Unit Injector Yoke Hold-Down Bolt Torque Specification CHU, CXU, GR, GU, PI

FSB 237-020, Unit Injector Yoke Hold-Down Bolt Torque Specification

(June 2017)

Unit Injector Yoke Hold-Down Bolt Torque Procedure

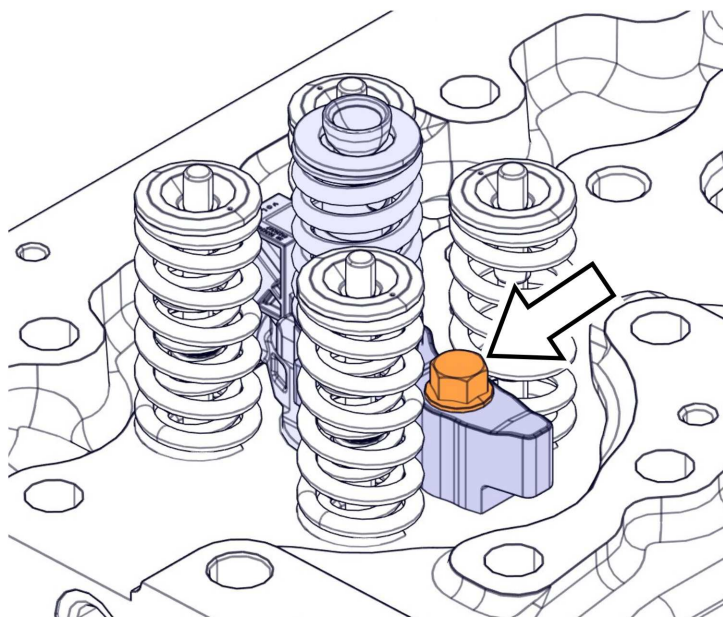
MACK CHU, CXU, GR, GU, and PI trucks built from 2009 to 2017 and equipped with MP7, MP8, and MP10 engines (EM-USA10, EM-USA14, and EM-USA17), will require a new torque specification for the Unit Injector Yoke Hold-Down Bolt. Effective immediately, the torque value in step 3 has changed to 25 +5/-0 Nm (18 +4/-0 ft-lb). See the torque procedure in steps 1 through 4 below. Additionally, the new yoke hold-down bolt torque will be updated in all service procedures, methods, and specification manuals.

- 1 Tighten 20 +5/-0 Nm (15 +4/-0 ft-lb).
- 2 Angle tighten 180 ± 5 Degrees.
- 3 Loosen until the torque is 25 +5/-0 Nm (18 +4/-0 ft-lb).
- 4 Angle tighten 90 ± 5 Degrees.
